To All Lamborghini Dealers and Licensed Service Point
From Customer Service Department
Subject New ground fixing point
Group LB824.9.71
Attachments -
Date 12.12.2006
Pages 6

New ground fixing point

Murciélago LP640 from VIN B71805 to VIN B72269.

Pict.3

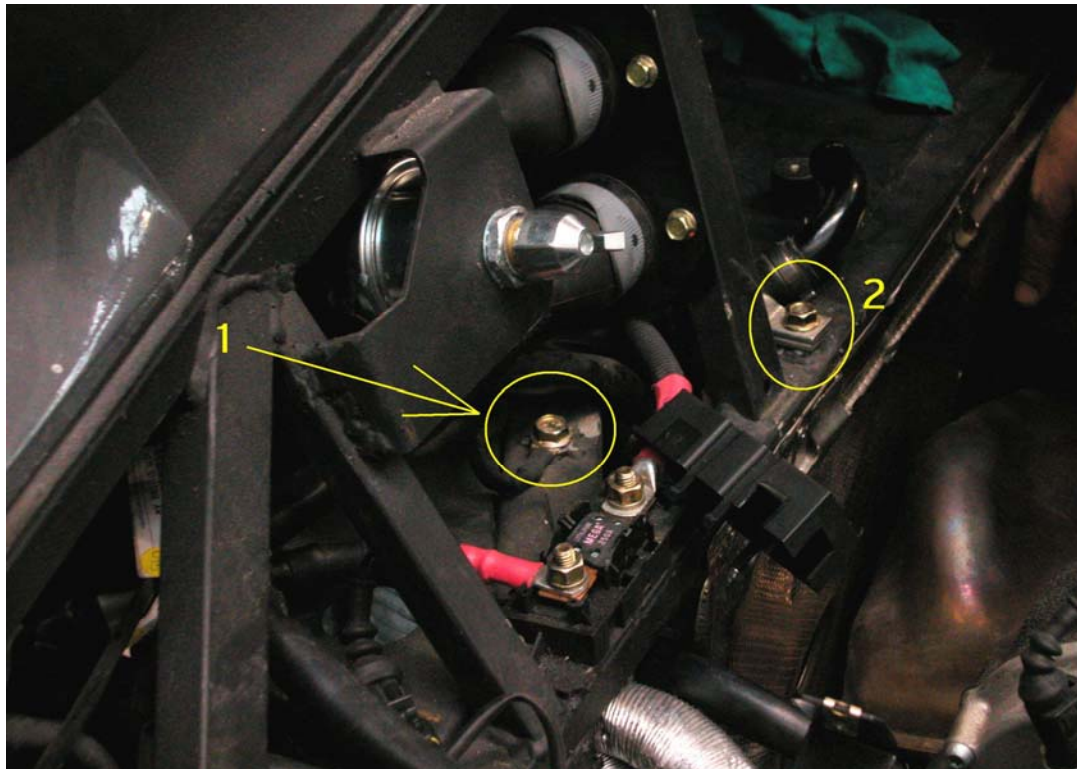
1.8 Look at the incorrect ground cable position as shown in picture 3, (reference nr. 1). Please move this cable onto the second ground fixing (reference nr. 2 of pict. 3). To do this you must replace the stud bolt because the old one is not long enough.

Stud bolt code: 008300814

Pict.4

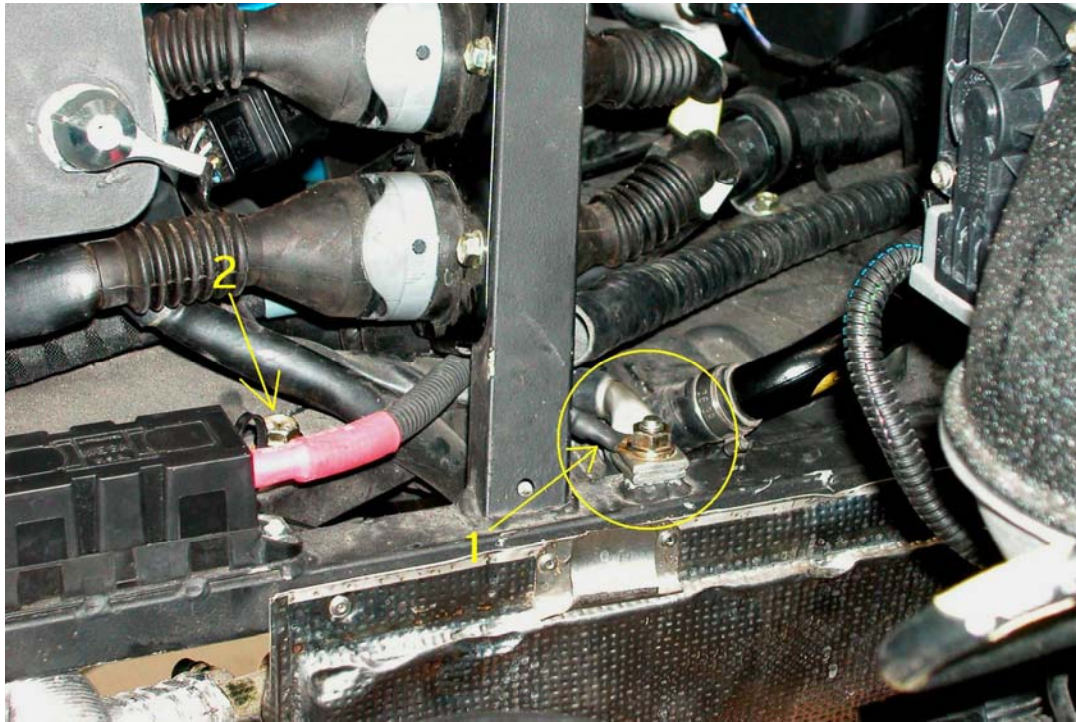
1.9 The cable position should be like shown in picture 4 ref. 1, the small cable will now be installed in the upper position to the other ones.

1.10 If the contact surface of the cable is rusty; remember to clean the connections using sand paper.

1.11 Reassemble the old screw in the position nr.2 of picture 4.
